Code of Practice for the Structural Use of Glass 2018

Amendments to the Code of Practice for Structural Use of Glass 2018 (July 2020)

Amendments to the Code of Practice for Structural Use of Glass 2018 (February 2024)

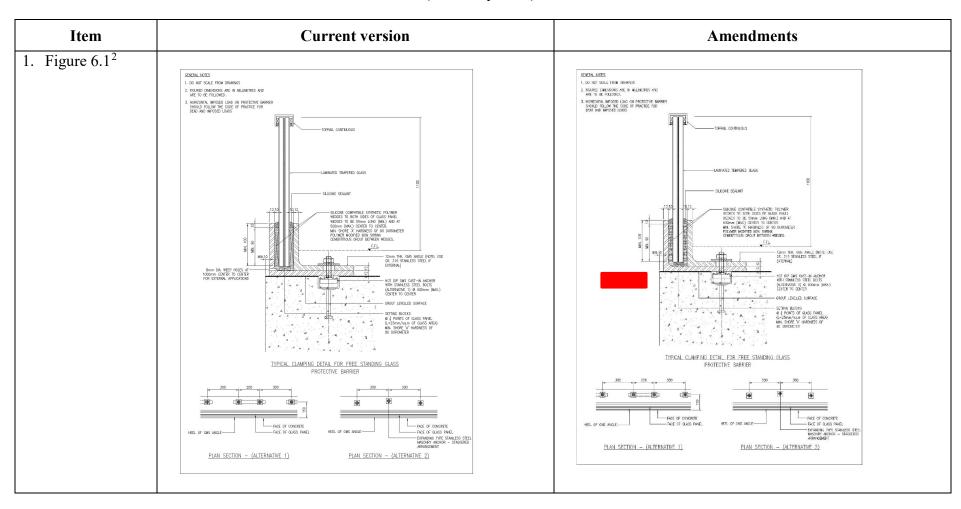
- (a) Figure 6.1 deletion of the 8mm dia. weep holes for external application in the typical glass balustrade details;
- (b) Clause $8.3.1(b)^1$ revision of the pressure p_2 for the repeated positive and negative pressure test; and
- (c) Figure B1.1 of Annex B revision of the expressions of failure load in item B1(2) Step k. and applied load.

² The 8mm dia. weep holes for external application in the figure is deleted.
